To: T10 Technical Committee
From: Timothy Hoglund, LSI Logic
Date: 07 May 2006
Subject: SAS-2 BREAK_REPLY

This proposal seeks to remove link layer race conditions present within the SAS-1.1 specification, namely the potential for BREAKs to cross on the wire with either OPEN_REJECTs or CLOSEs leading to potential livelock scenarios involving Open and Break Timeouts.

Figure 32 — Transmit data path in a SAS phy

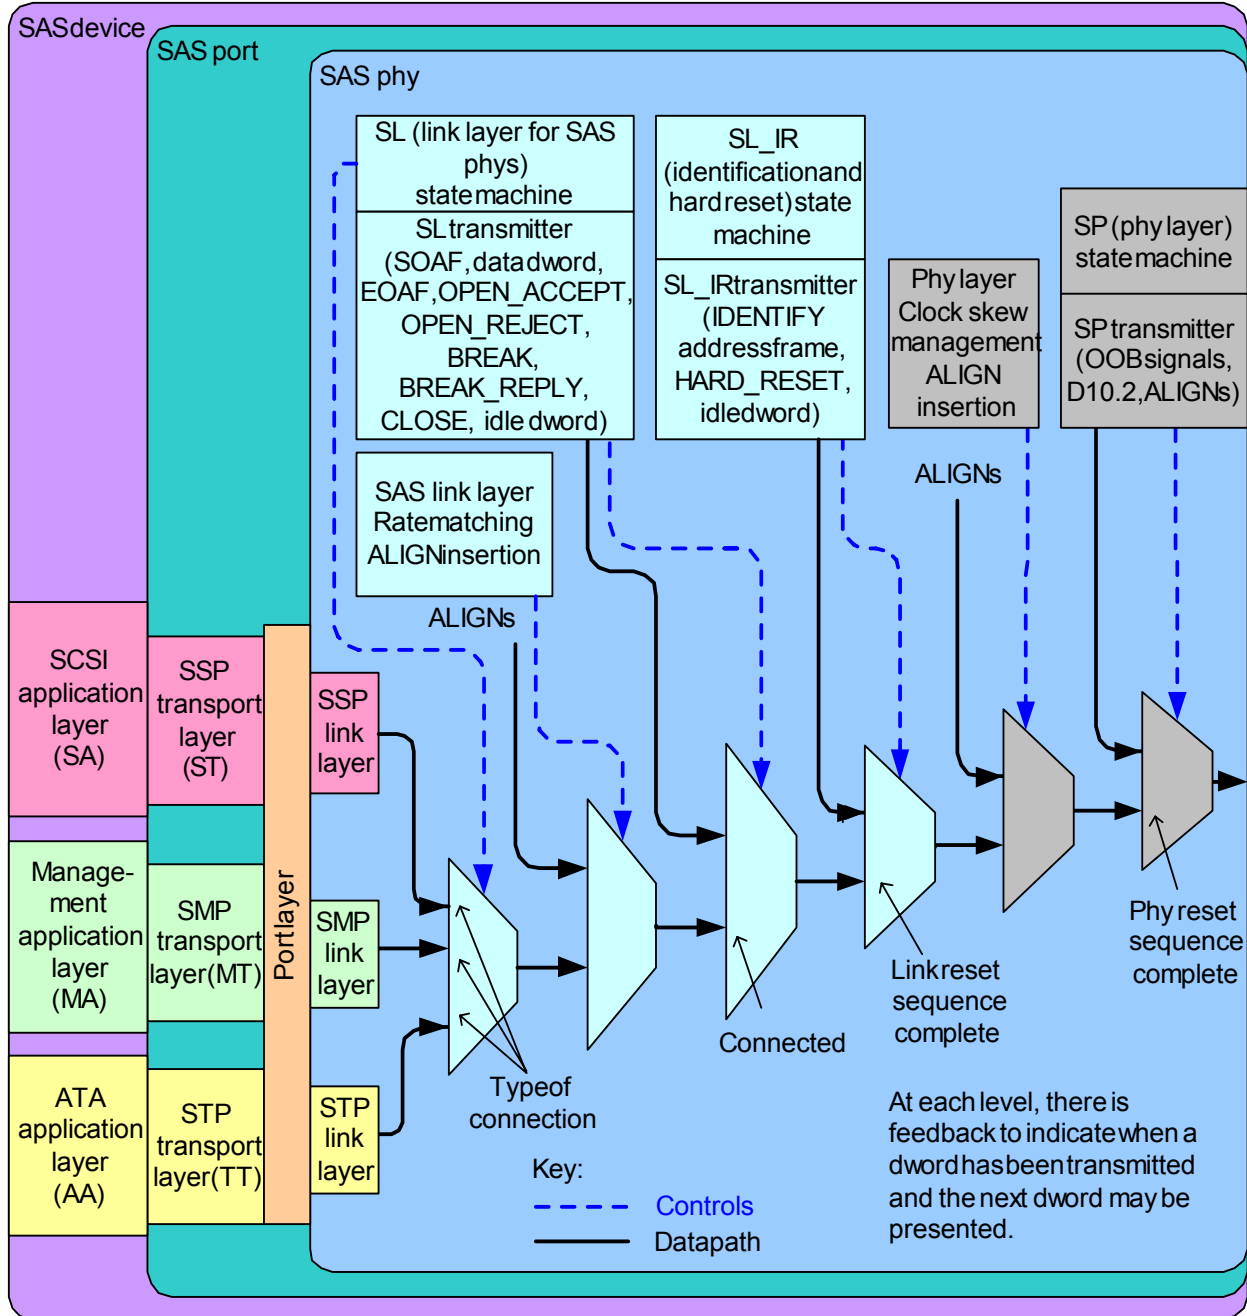
[added BREAK_REPLY to Figure 32]

Figure 36 — Transmit data path and state machines in an expander phy

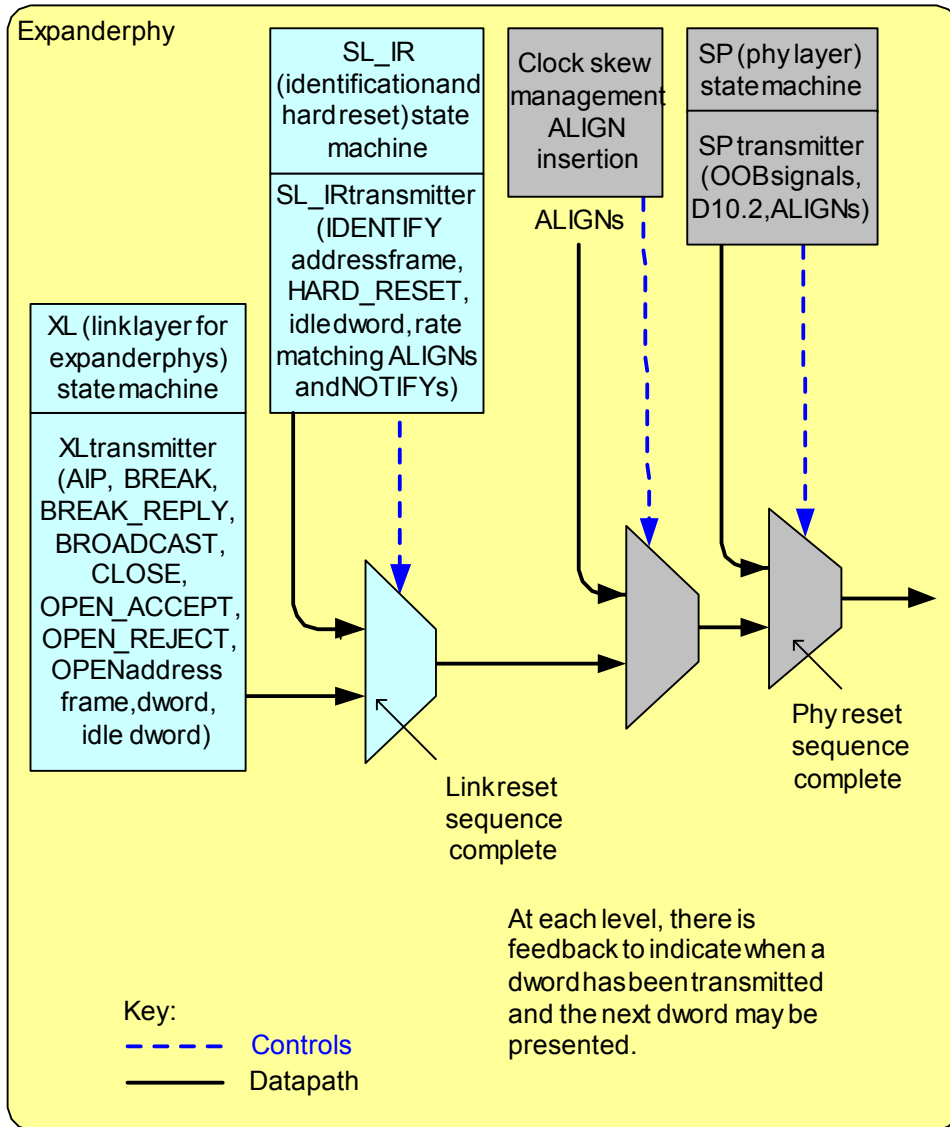
[added BREAK_REPLY to Figure 36]

Figure 142 — Connection request timeout example

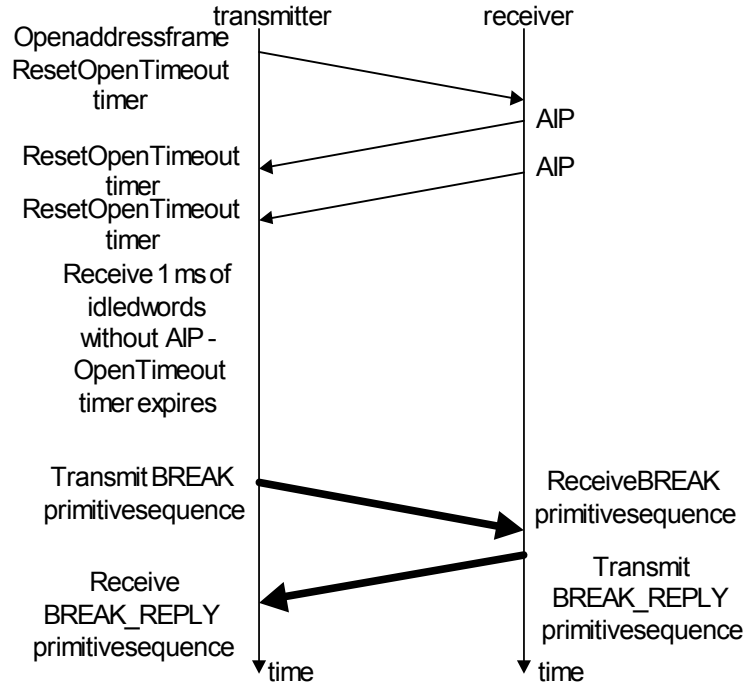
[changed BREAK response to BREAK_REPLY in Figure 142]

NOTE NN - SAS phys not utilizing the BREAK_REPLY method of responding to received BREAK primitive sequences transmit BREAK instead of BREAK_REPLY.

Figure 146 — SL (link layer for SAS phys) state machines (part 2)

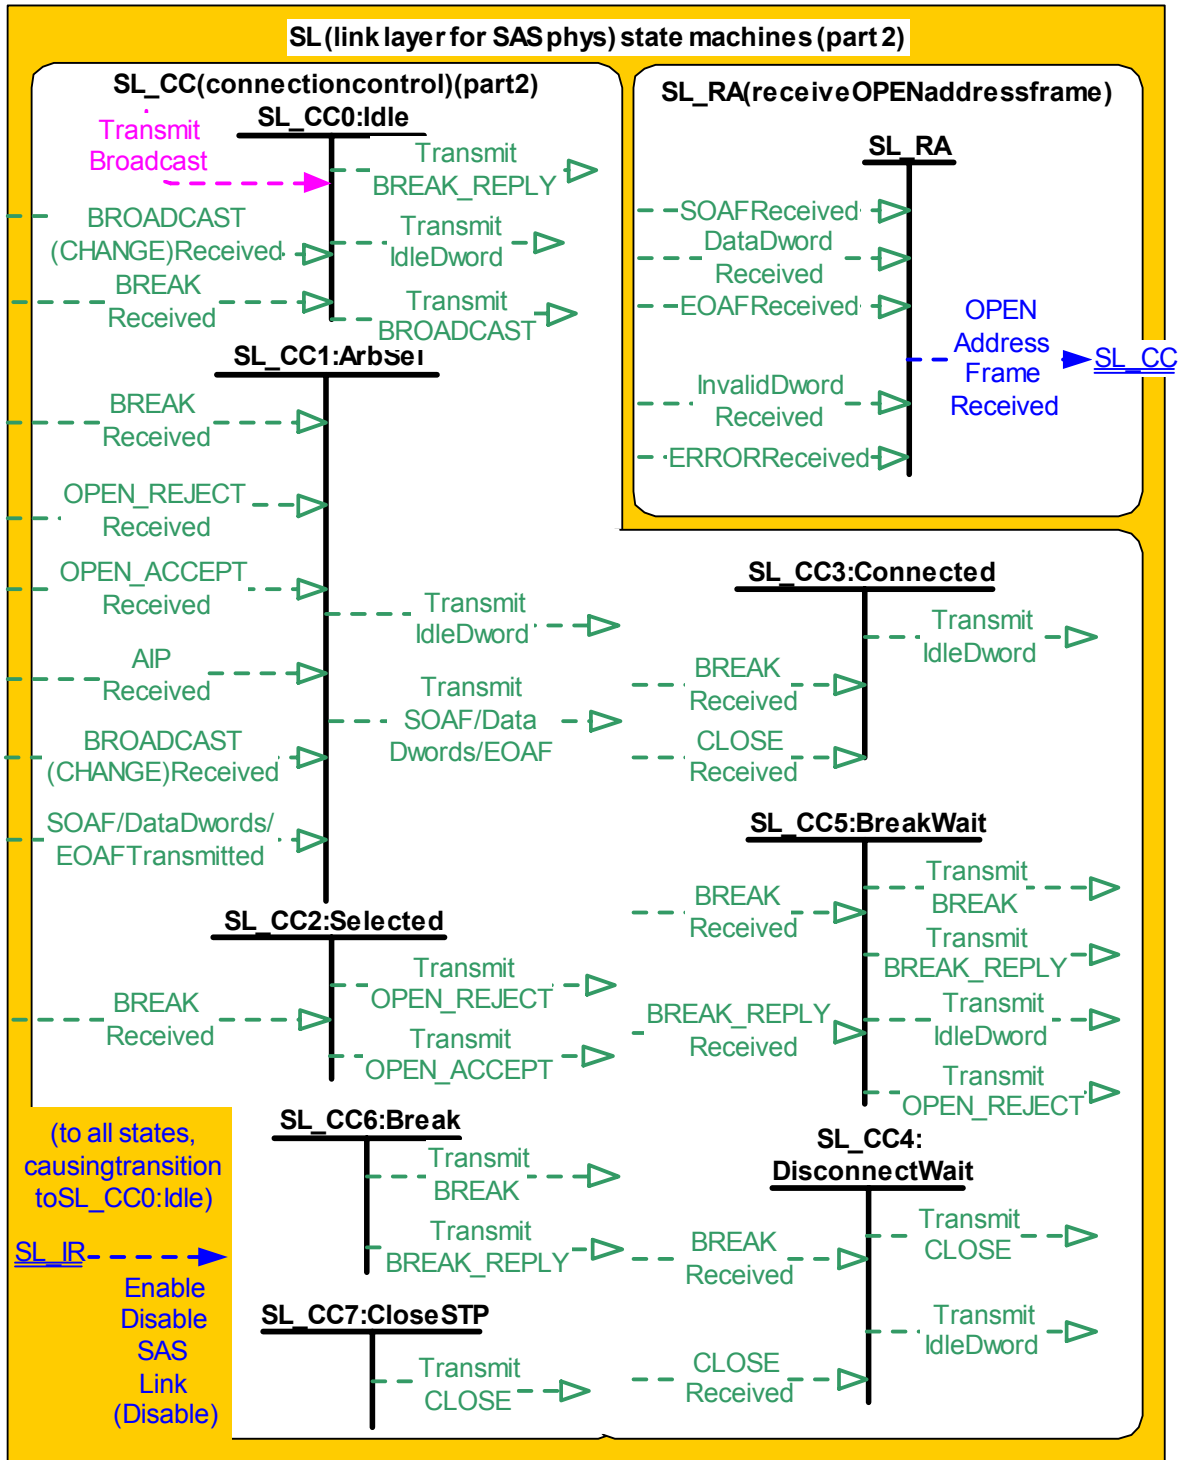
[added Transmit BREAK_REPLY to SL_CC0, SL_CC5, SL_CC6]

[added BREAK_REPLY received to SL_CC5]

[added BREAK Received to SL_CC0]

Figure 147 — XL (link layer for expander phys) state machine (part 1)

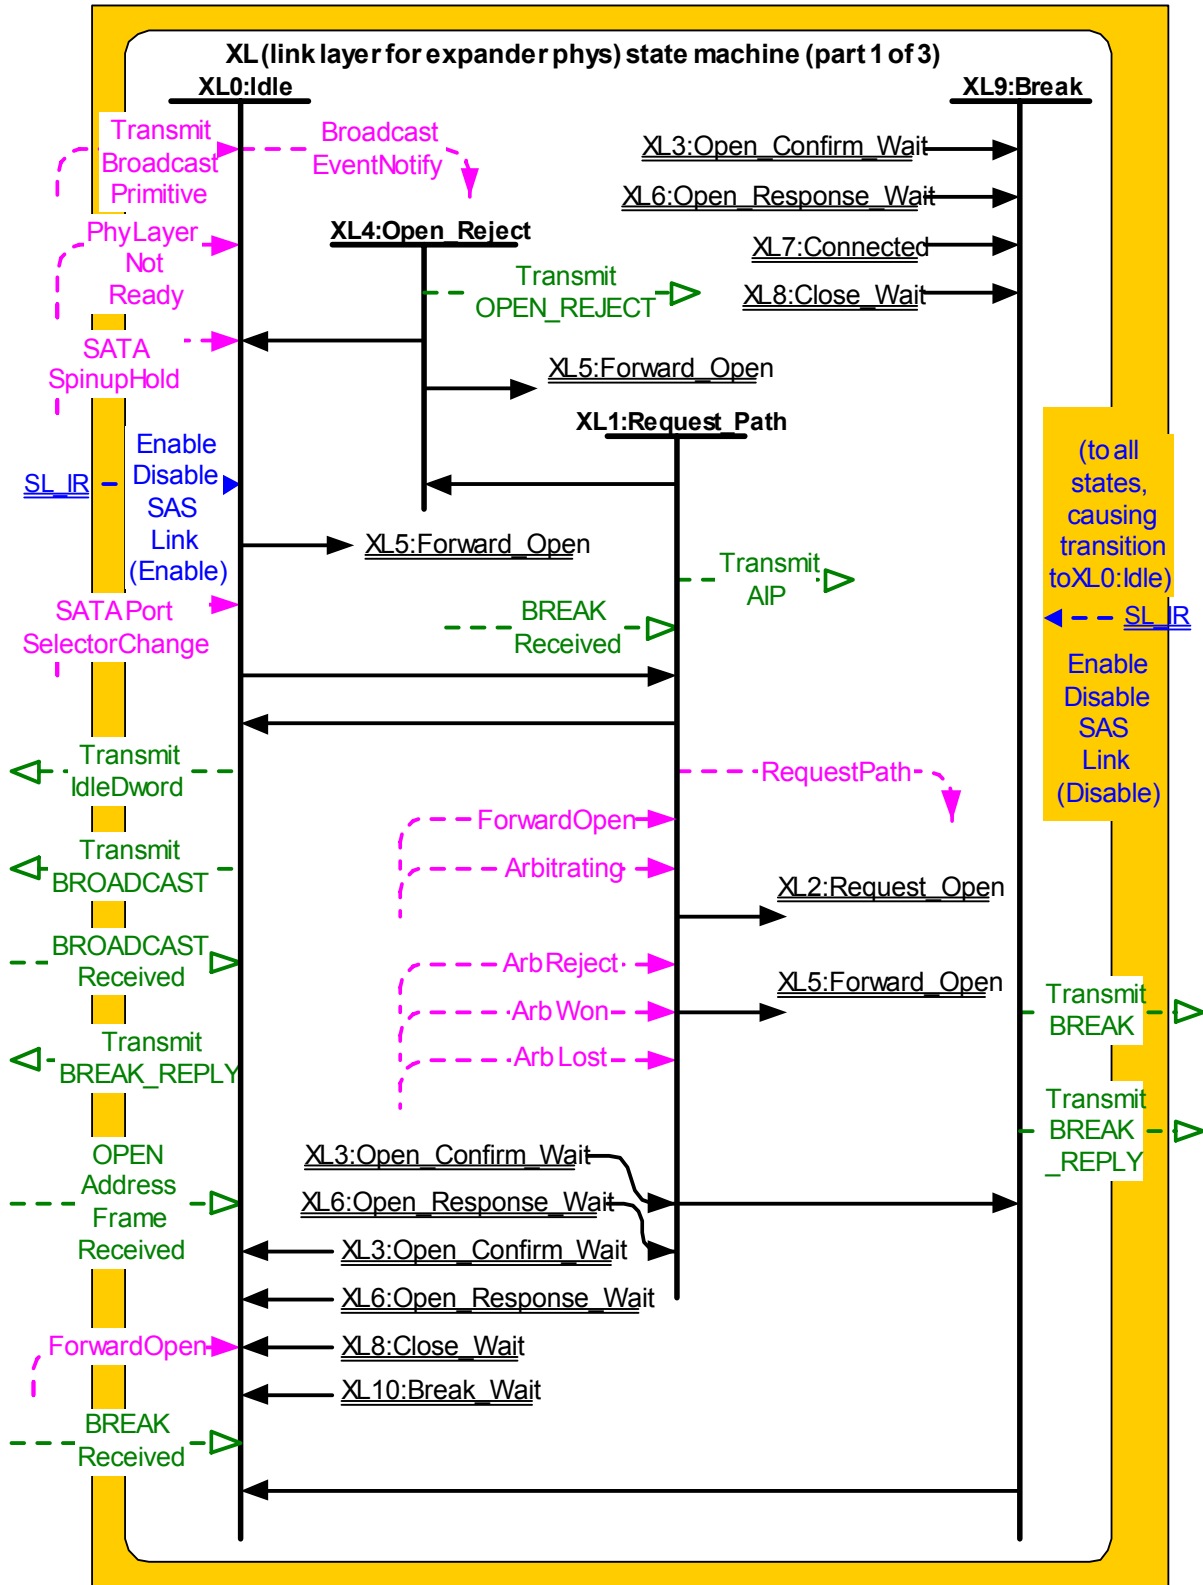
[added Transmit BREAK_REPLY to XL0 and XL9]
 [added BREAK Received to XL0]

Figure 149 — XL (link layer for expander phys) state machine (part 3)

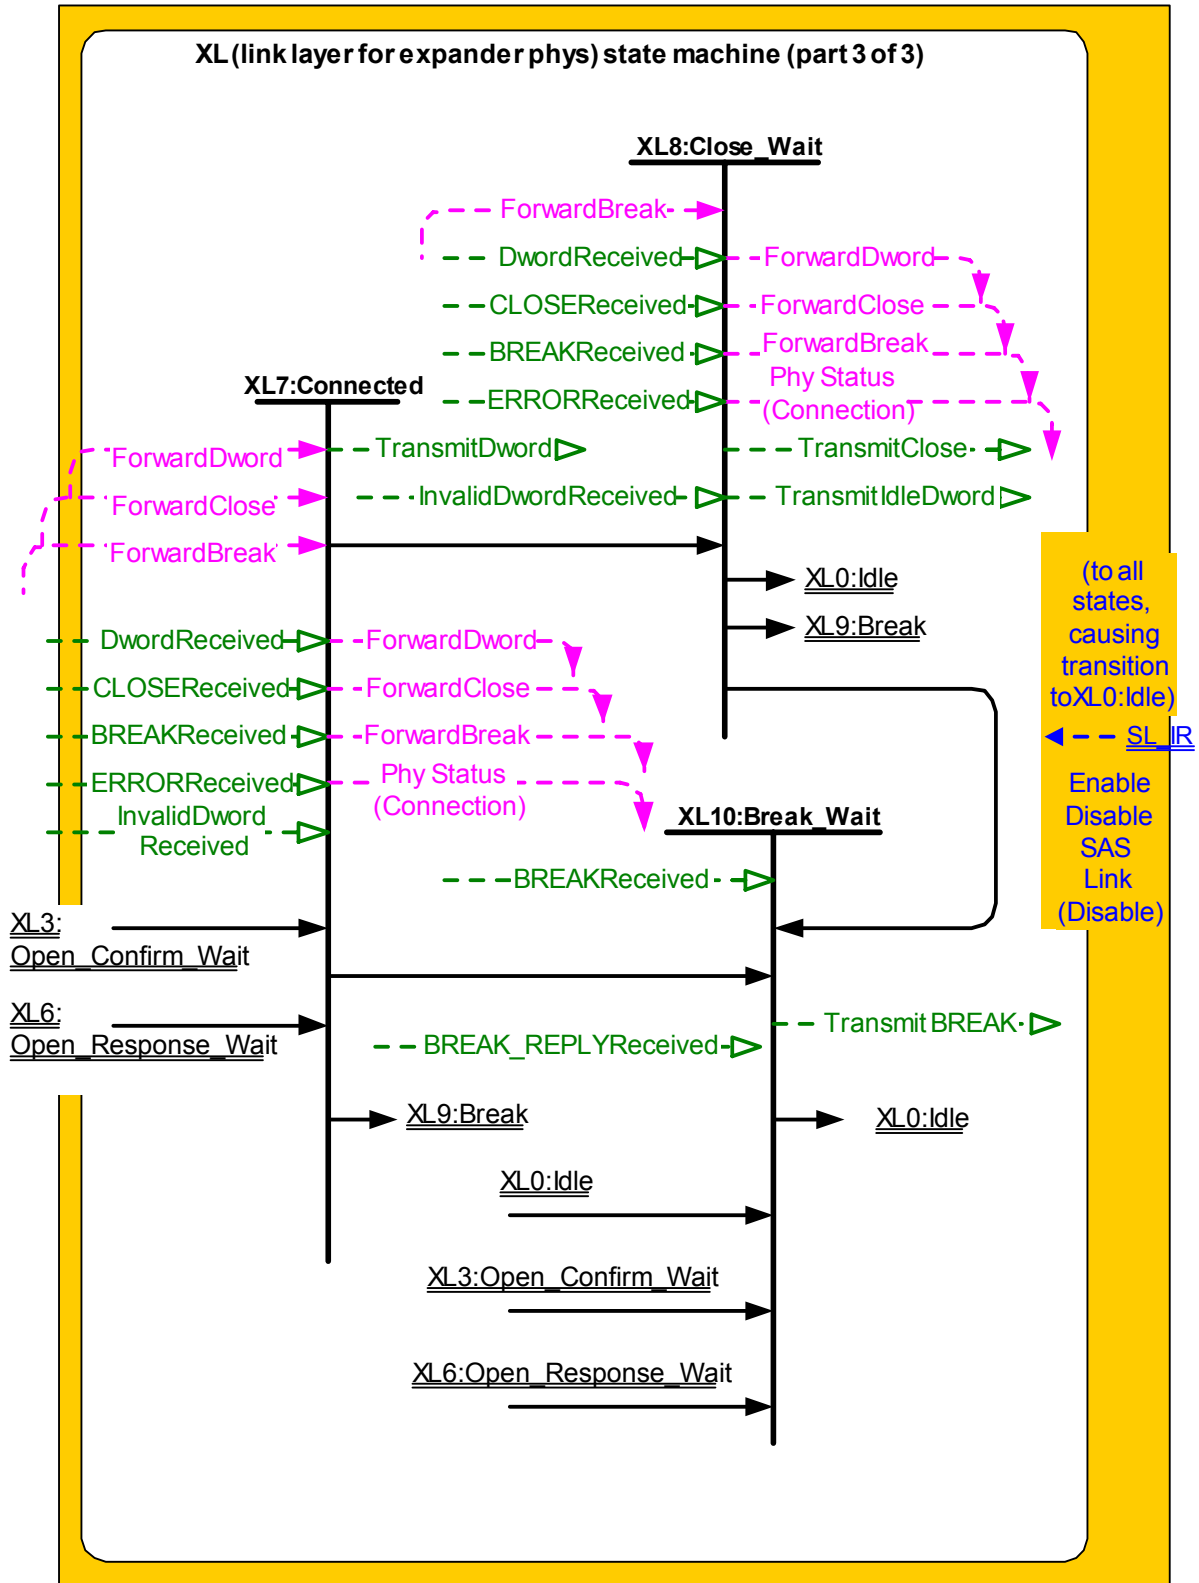
[added BREAK_REPLY Received to XL10]
